Project Name:	Bartons Road, Havant
Document Reference:	106.0019/TN/2
Document Name:	Transport Note
Prepared By:	Alex Stephenson (July 2021)
Checked By:	Rob Hardyman (July 2021)
Approved By:	Paul Basham (July 2021)

1. INTRODUCTION

- 1.1 This Transport Note (TN) has been prepared by Paul Basham Associates on behalf of Fortitudo Ltd to support a planning application for a mixed-use development comprising 175 apartments, a McDonald's drive-thru and a Costa Coffee drive-thru, at the site of the former Scottish and Southern Energy (SSE) offices on Bartons Road, Havant.

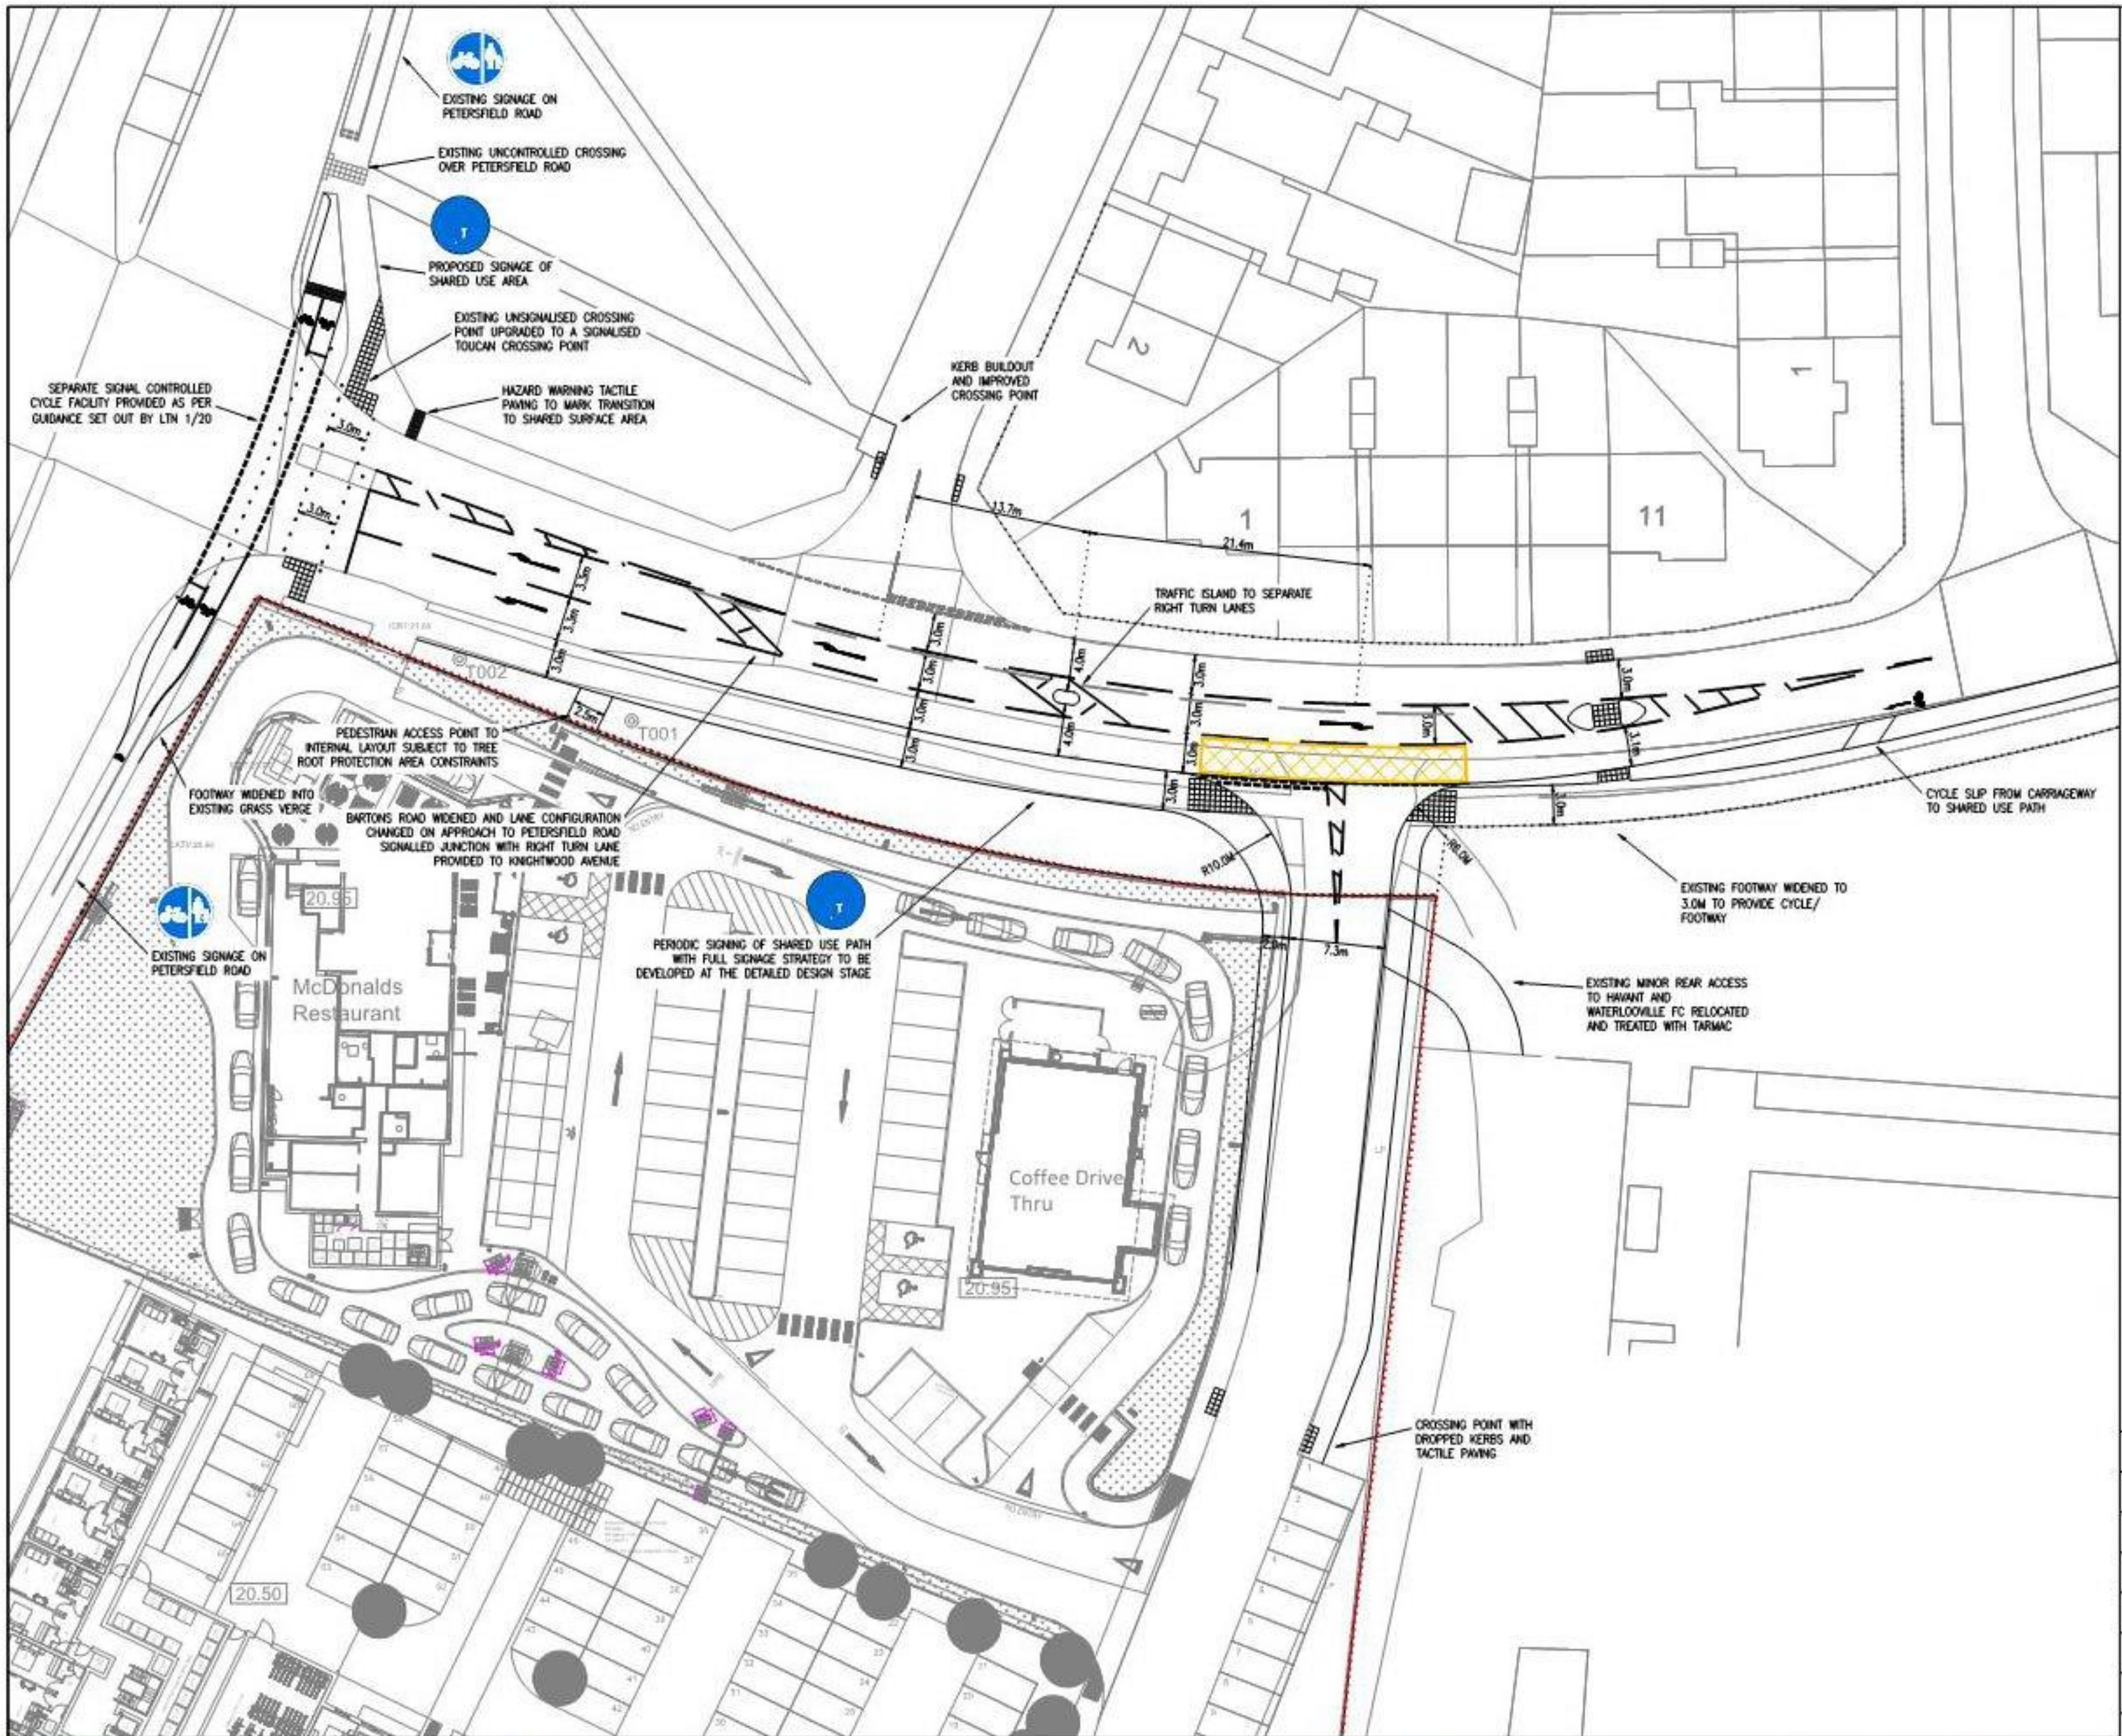
Regarding the engineering design of the access we also have the following comments on drawing 106.0019.007 and these have already been sent to you back in the beginning of February but I have amended them to provide additional clarity.

- The proposed shared surface signs are now shown on the drawing with a full signage strategy to be developed at the detailed design stage
- Dimensions have been added to clarify particular road widths and the lengths of the right turn lanes

- The crossing point over Knightwood Avenue has been moved south and 2.5 x 25m visibility splays are shown
- The Toucan crossing point has been widened slightly to 3.0m
- A 2.0m footway is now shown on the east side of the access road with associated crossing point
- The centreline of the access road is now perpendicular to Bartons Road
- The access road now includes hatching to narrow the northbound lane and discourage simultaneous left and right turn movements
- The access tracking drawing now shows an HGV manoeuvring past a panel van instead of a car

- Visibility splays added to the Knightwood Avenue crossing
- Kerb buildout provided at Petersfield Road/ Bartons Road junction

Plan attached showing the locations of the problems identified as part of this audit (location numbers refer to paragraph numbers in the report).

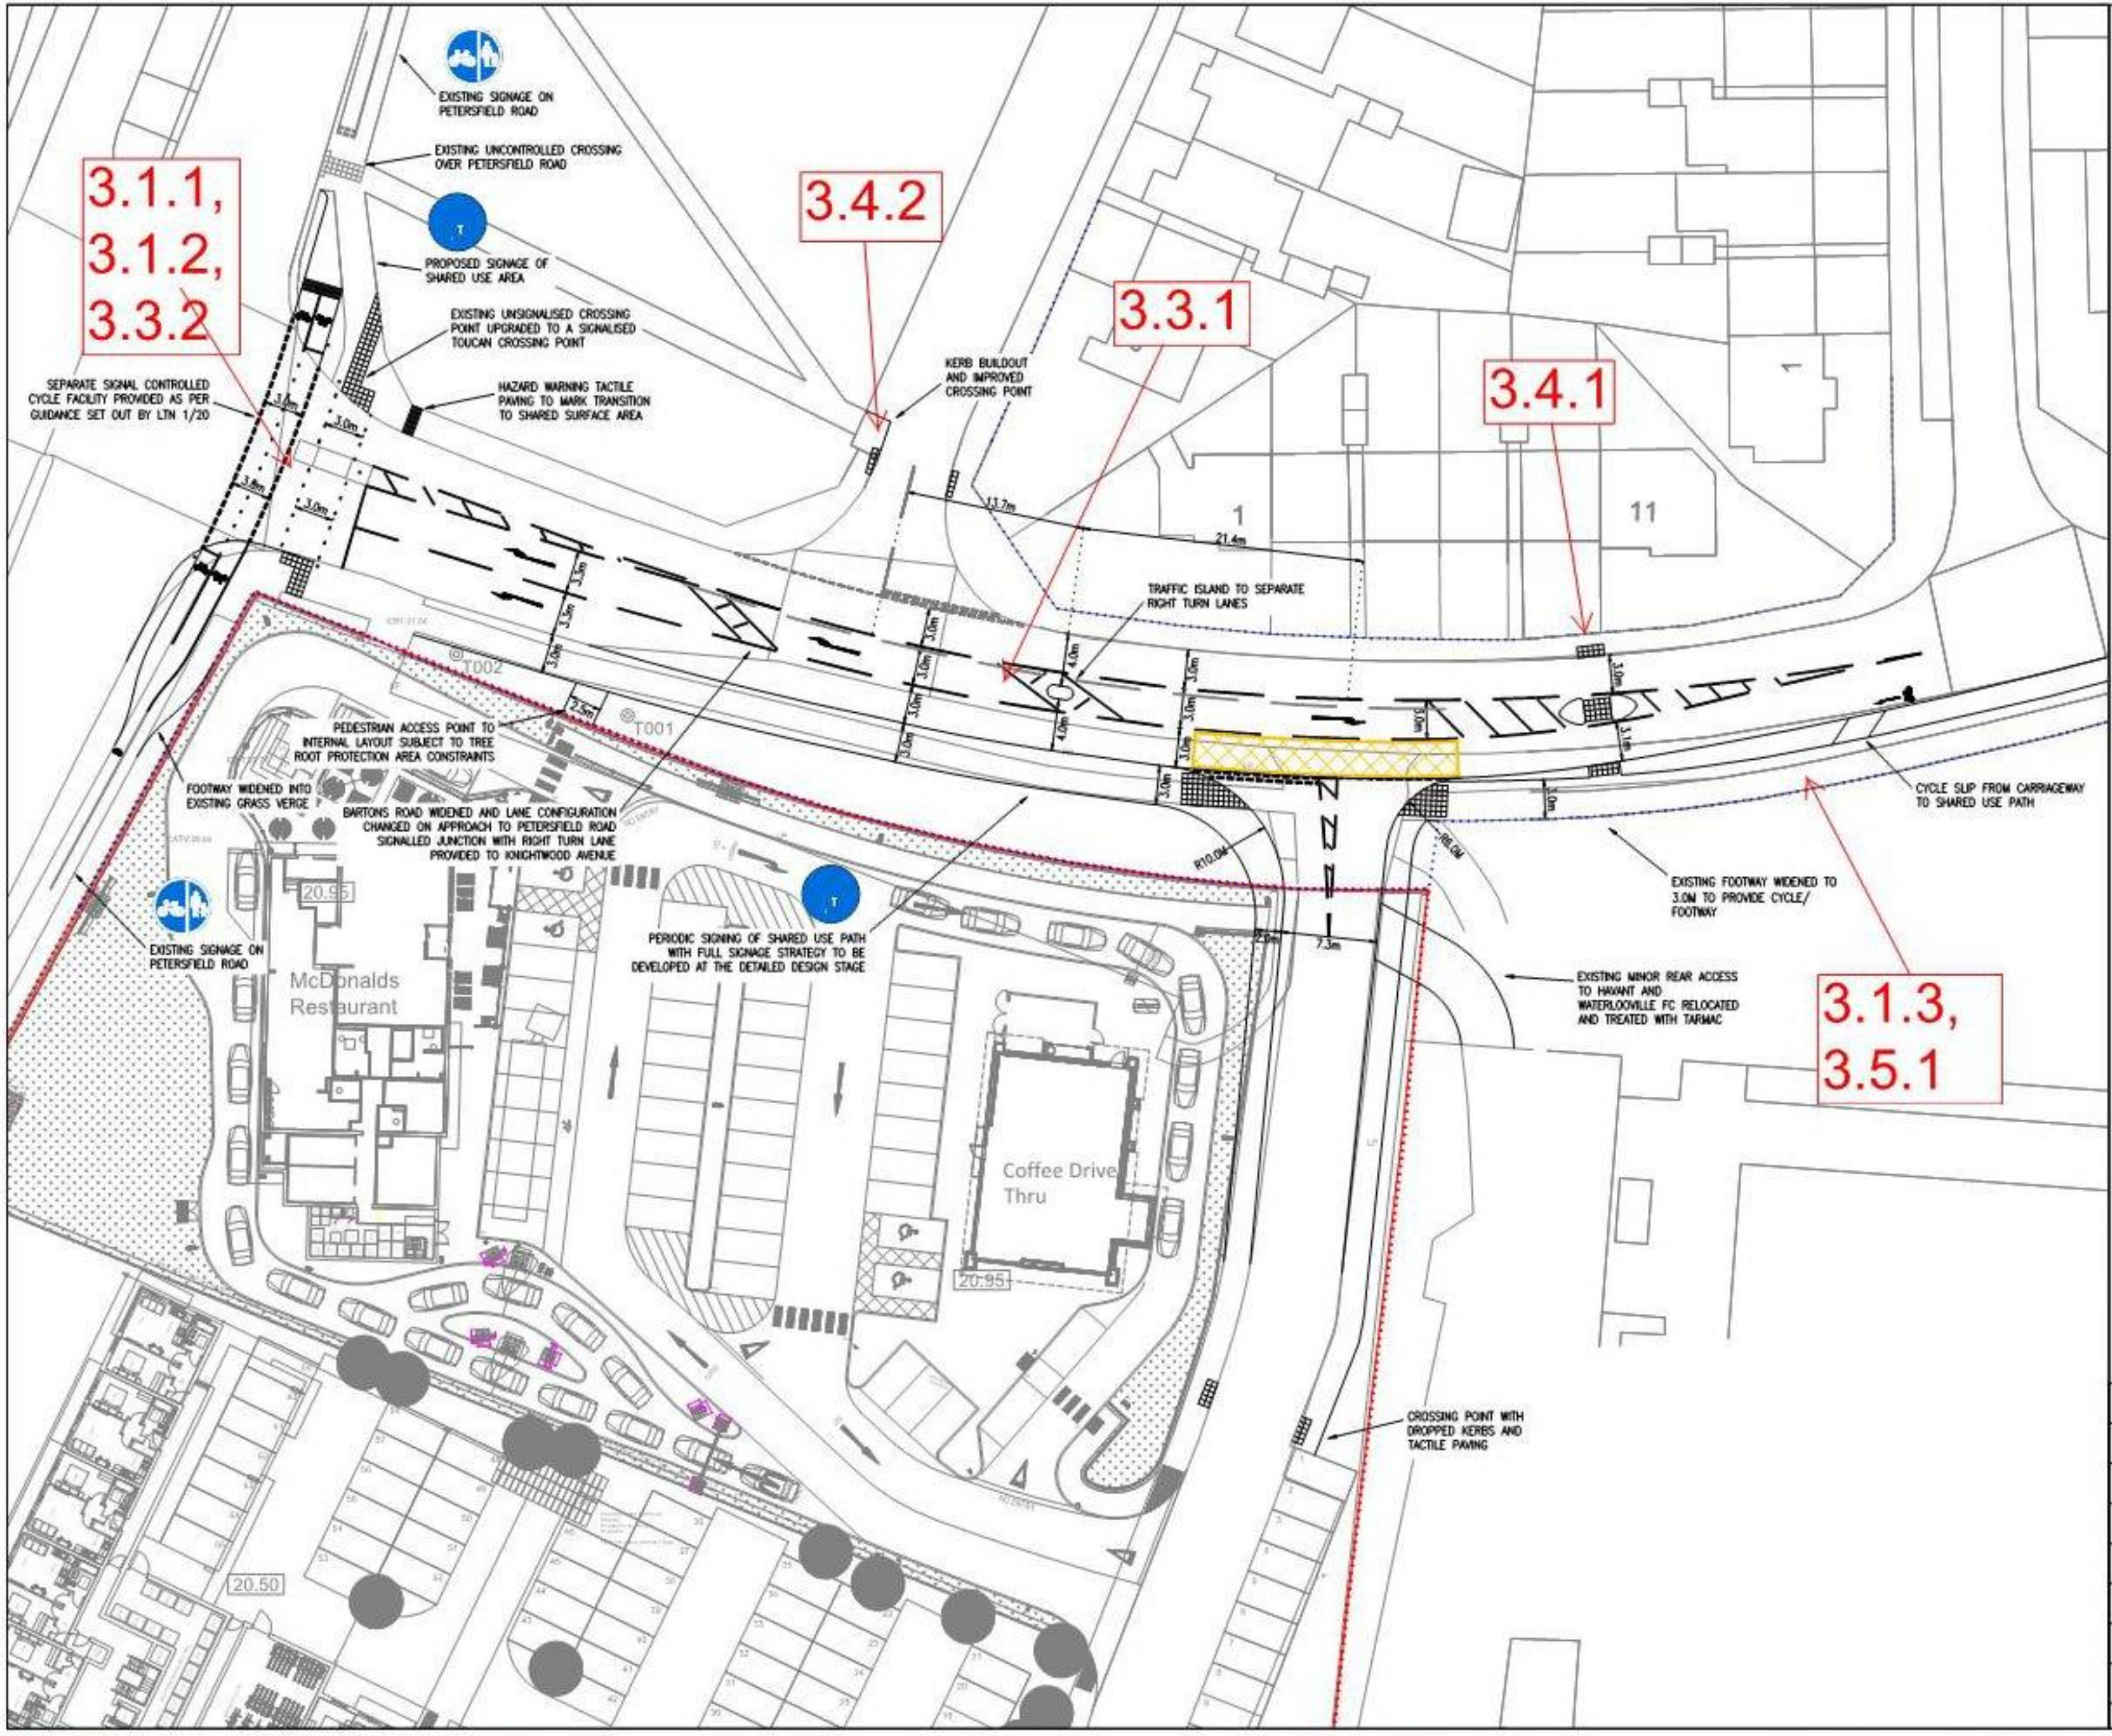
3.4.1 Whilst pedestrian intervisibility appeared adequate there was scope for the visibility splay to the east to be improved and obstructed should the hedge line continue to grow – see figure 1. Restricted restrict visibility could lead to vehicle to pedestrian collisions or rear end shunt collisions.	It is recommended that the hedge should be cut back and that a regular maintenance programme to retain the visibility splay should be employed.	The hedgerow should be regularly cut back as required as part of HCC's maintenance programme
